Addendum / Addenda

Project Description / Description de projet S77 S77-Modify Laser Lab Chilled Water System		
Solicitation No./N° de sollicitation 16-22099	Project No./N° de projet 4060	W.O. No./N° d'ordre de travail B043-BO43-FAC-00
Departmental Representative / représentant ministériel Allan Smith		Date October 27, 2016
Notice: This addendum shall form part of the tender documents and all conditions shall apply and be read in conjunction with the original plans and specifications.		Nota: Cet addenda fait partie intégrale des dossiers d'appel; toutes les conditions énoncées doivent être lues et appliquées en conjonction avec les plans et les devis originaux.

Project Description / Description de projet Building S-77 Modify Laser Labs Chiller Water System		
Solicitation No./ No de sollicitation	Project No./N ^o de projet 4060	W.O. No./N ^o d'ordre de travail
Departmental Representative / représentant ministériel Allan Smith		Date Oct 21, 2016
<p>Notice: This addendum shall form part of the tender documents and all conditions shall apply and be read in conjunction with the original plans and specifications.</p>		<p>Nota: Cet addenda fait partie intégrale des dossiers d'appel d'off

dwg.no. 4060-G02

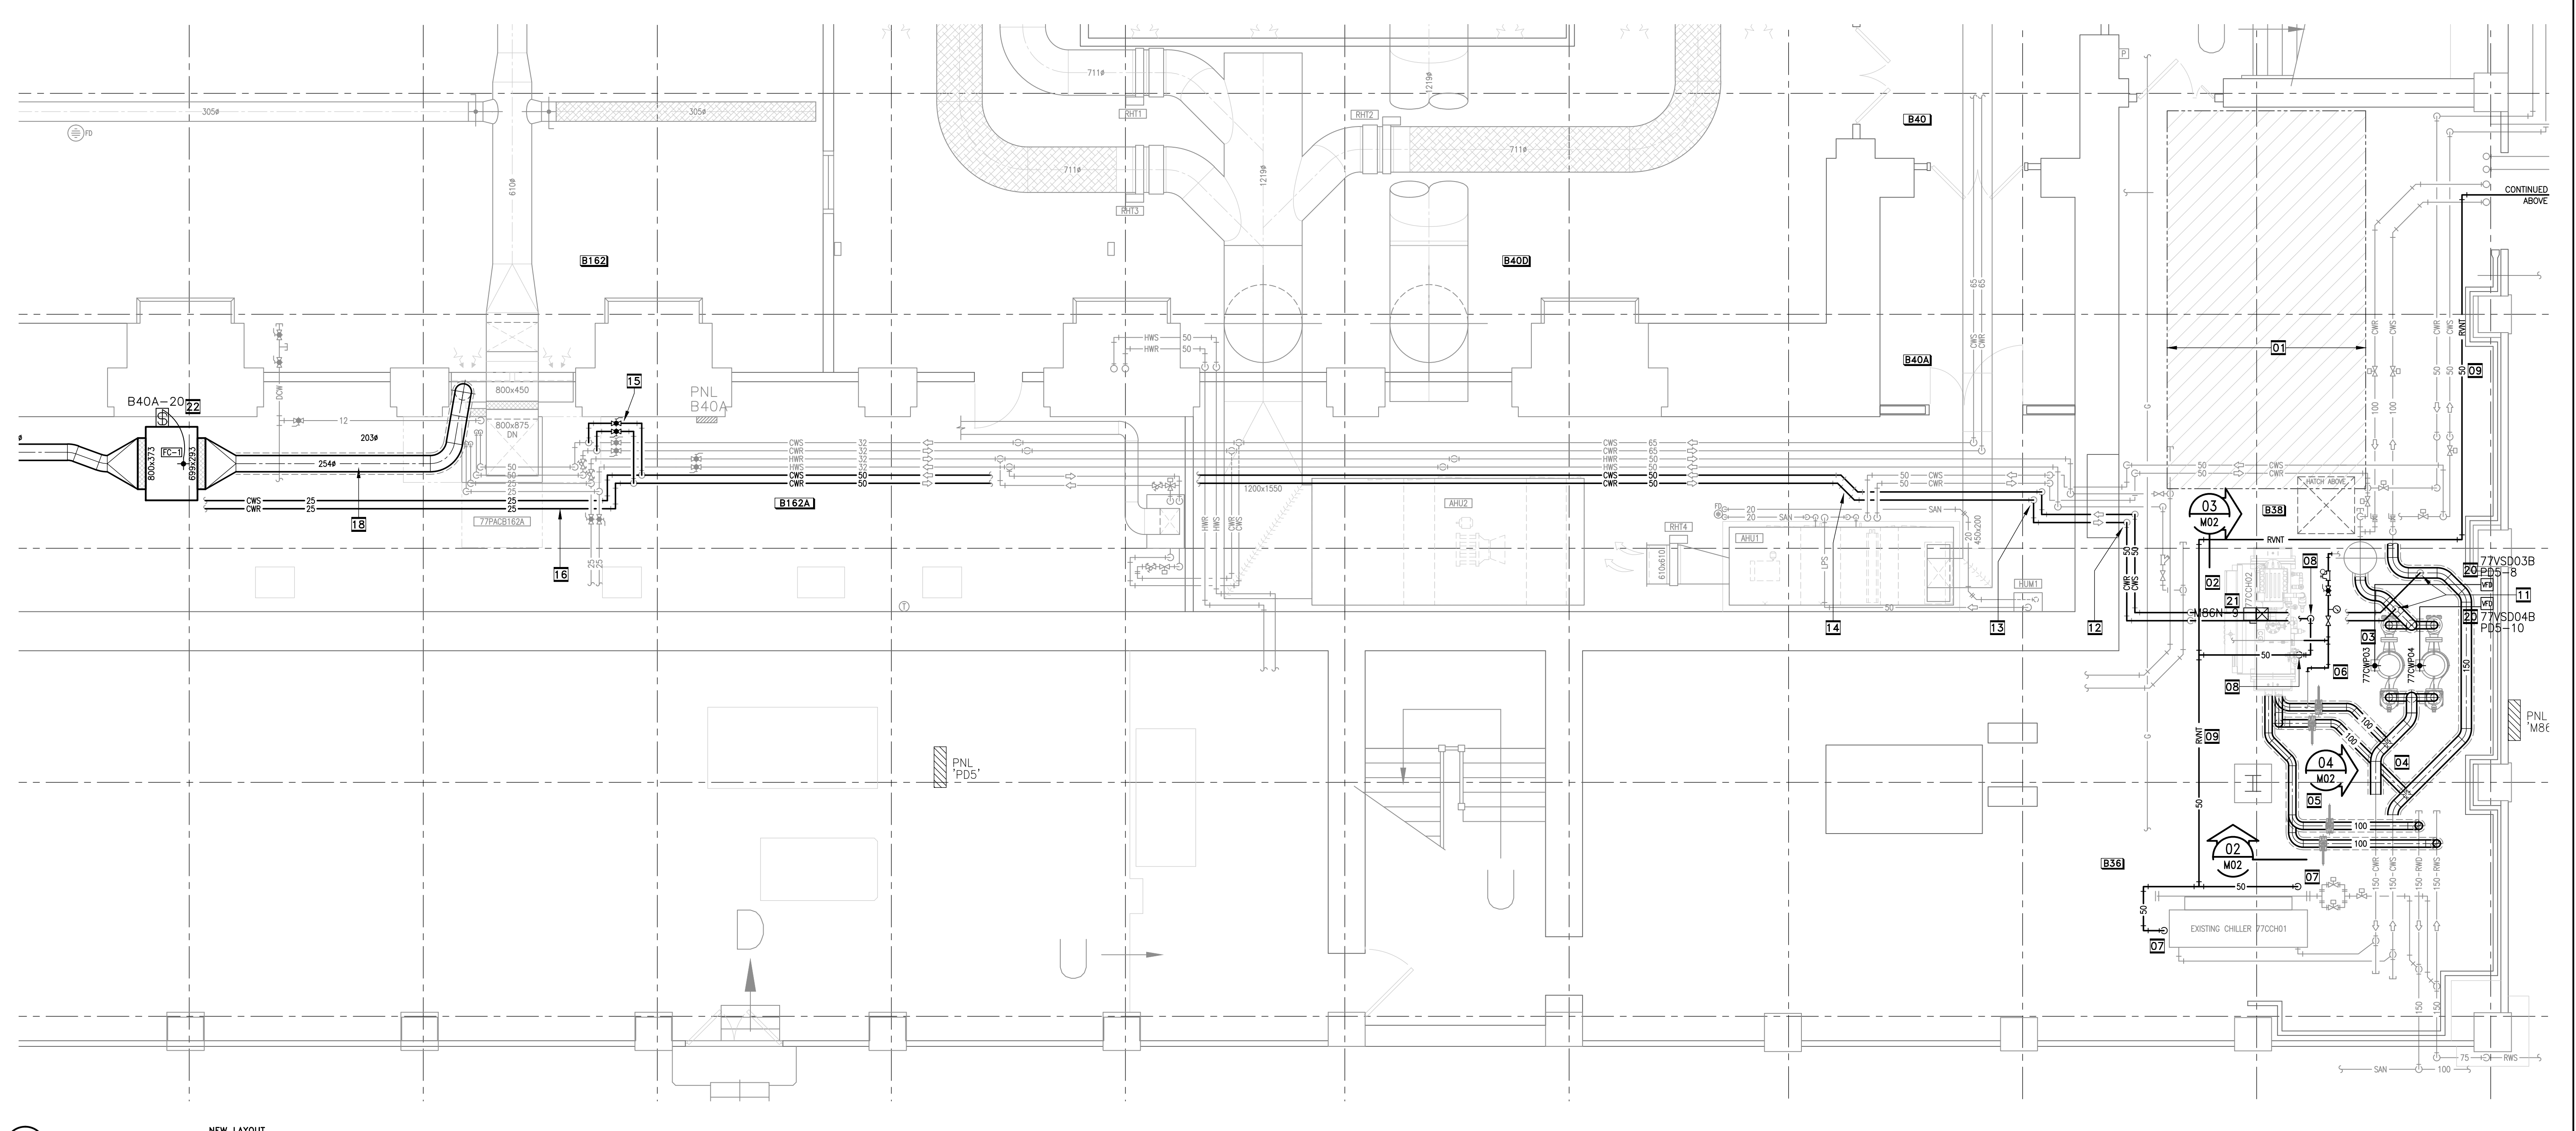
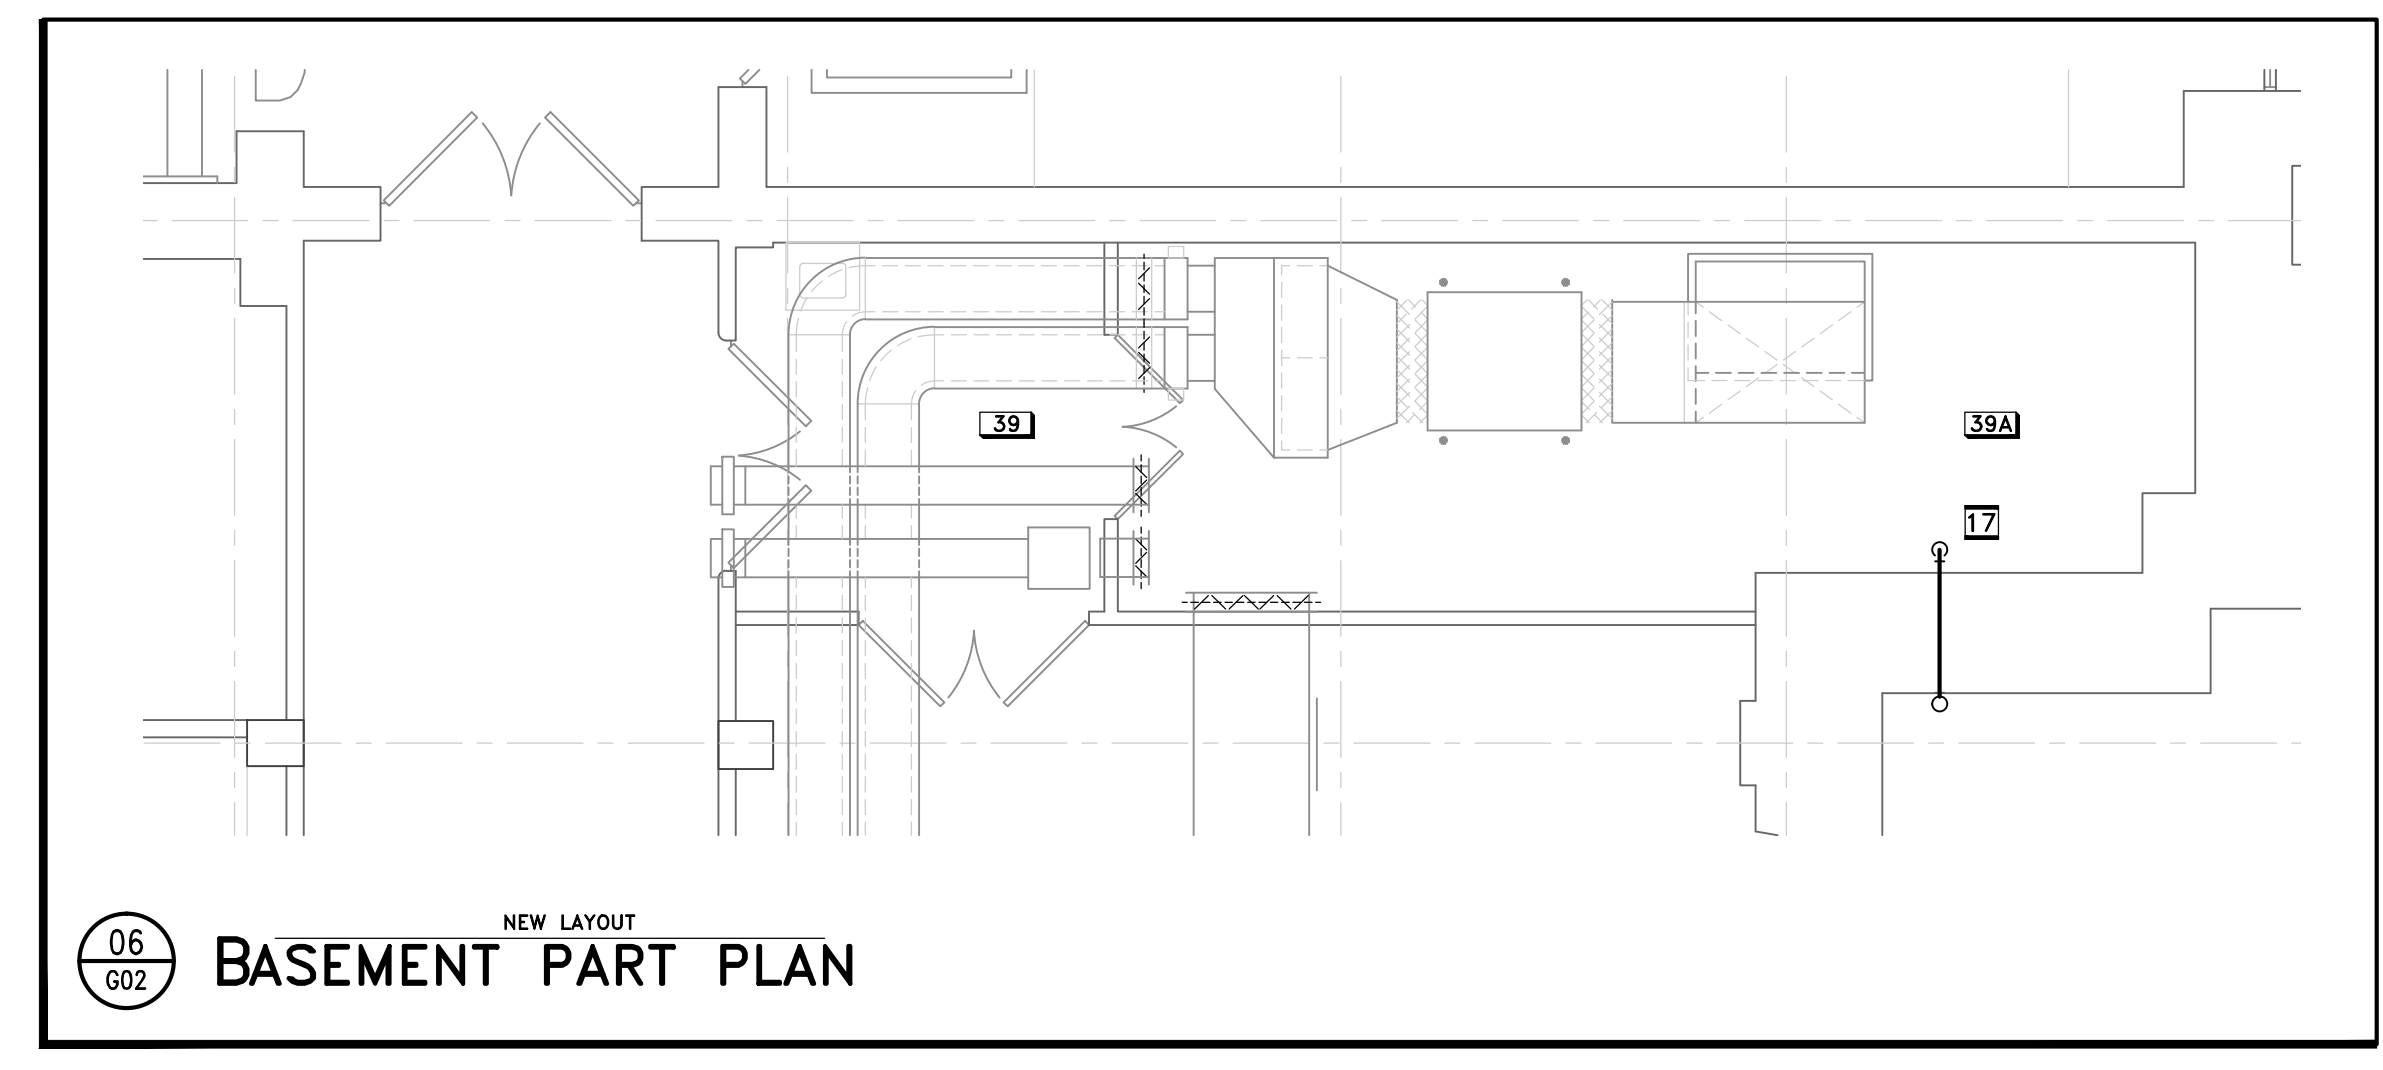
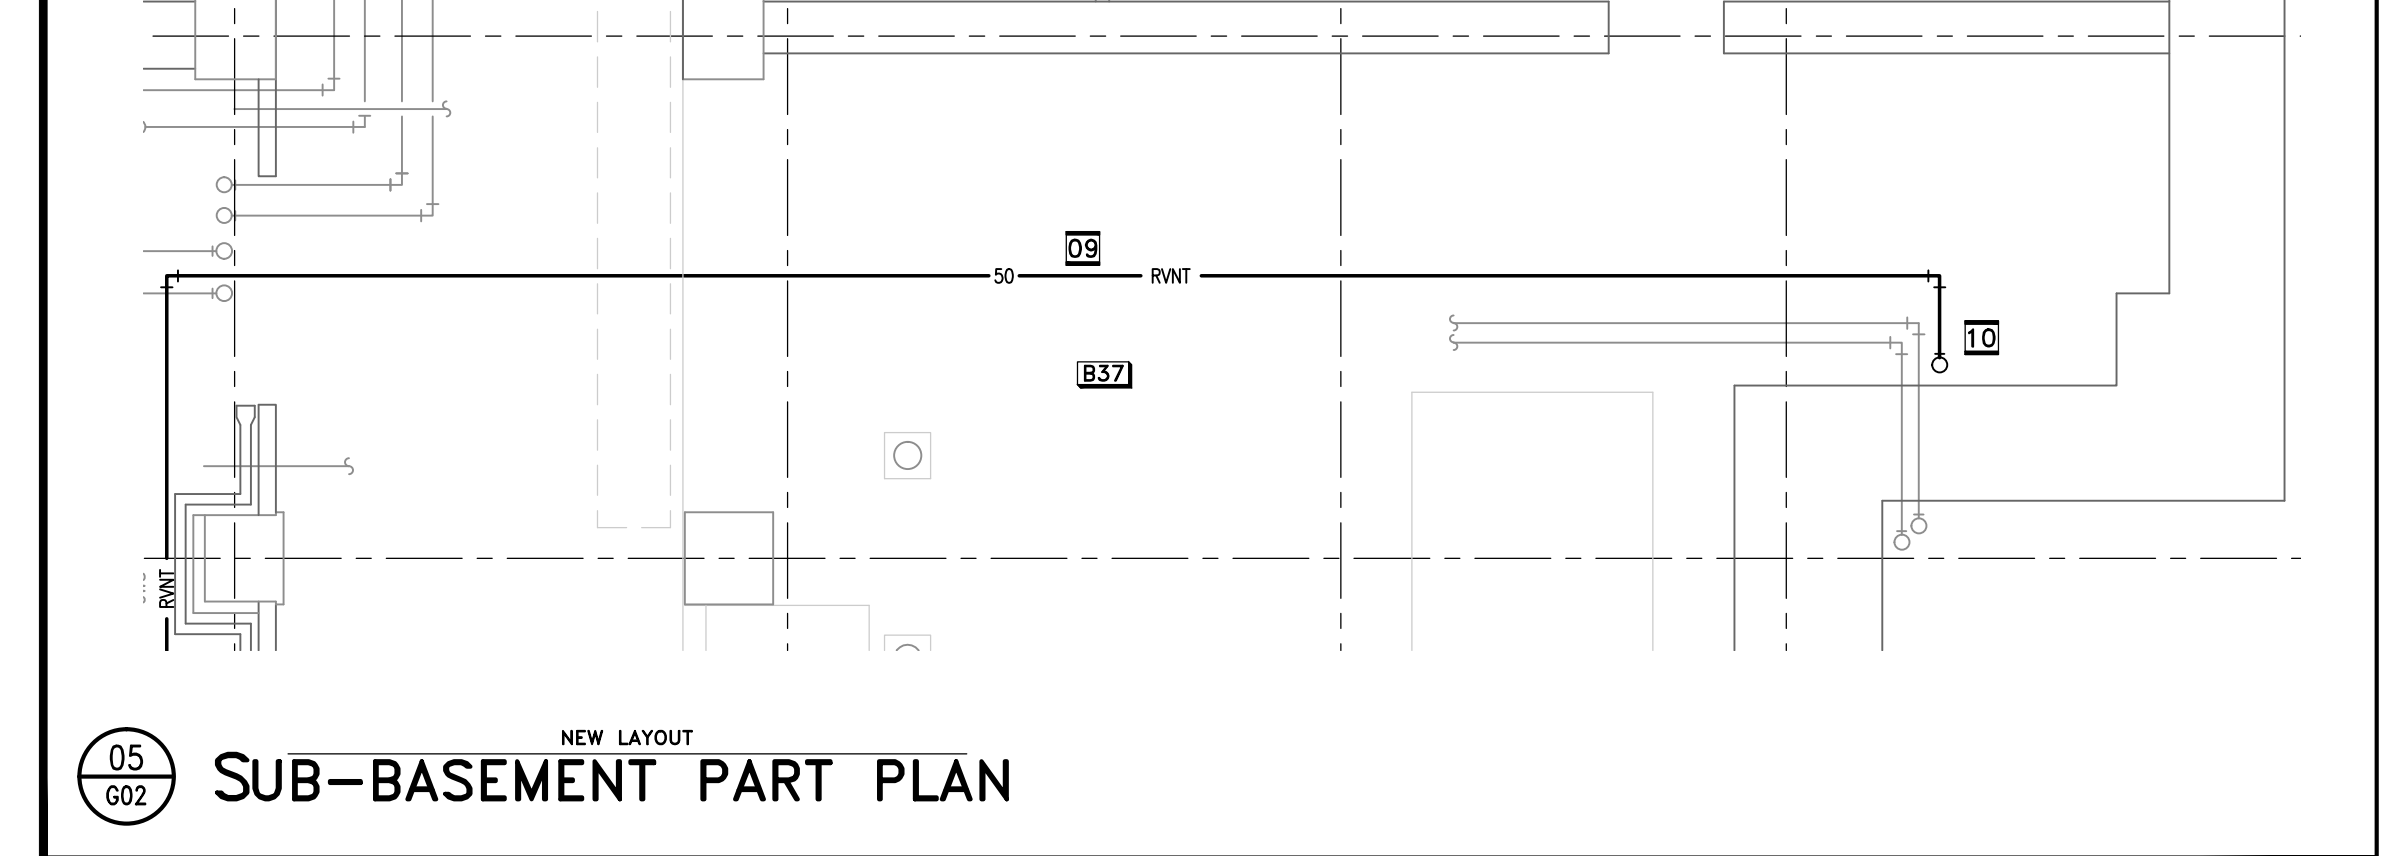
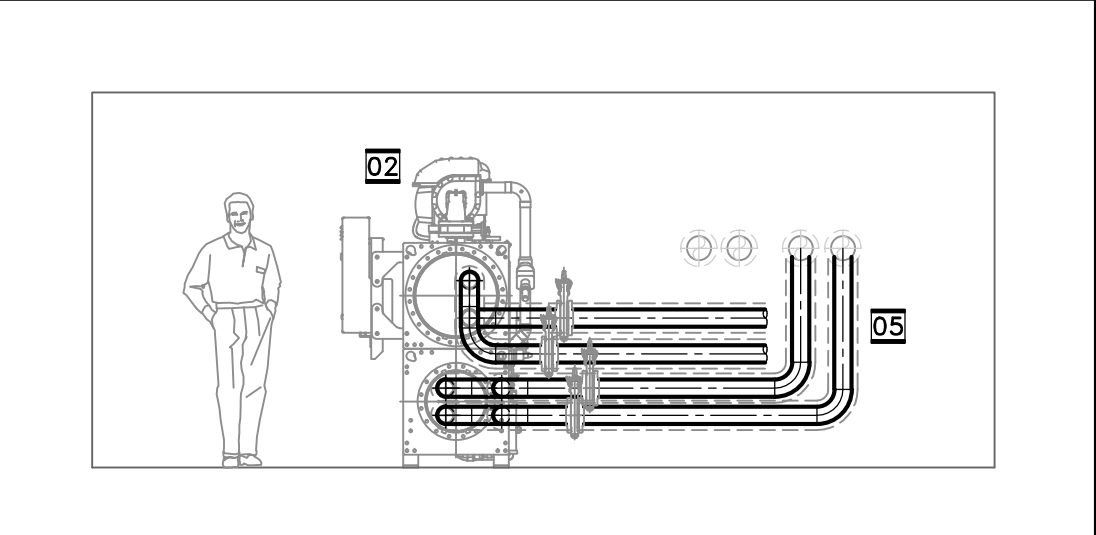
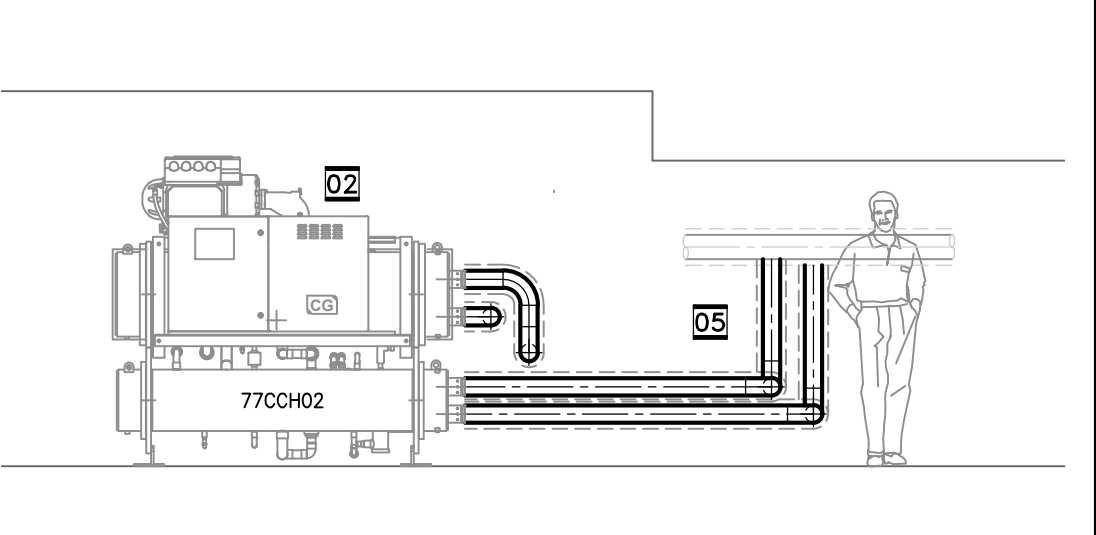
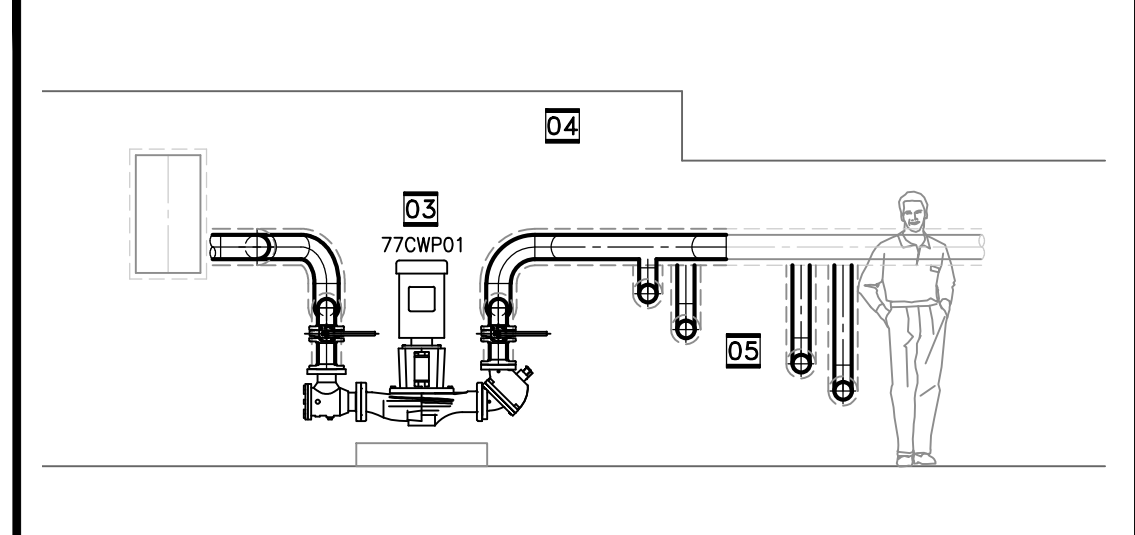
Refer to drawing 4060-G02 note 20.

Add. 'provide VFD and make all connections. VFD to be vertical, E-Clipse, c/w disconnect switch and suitable for motor rating. Standard of acceptance : ABB ACH550-VDR-022A-6. Refer to specification for additional information. '
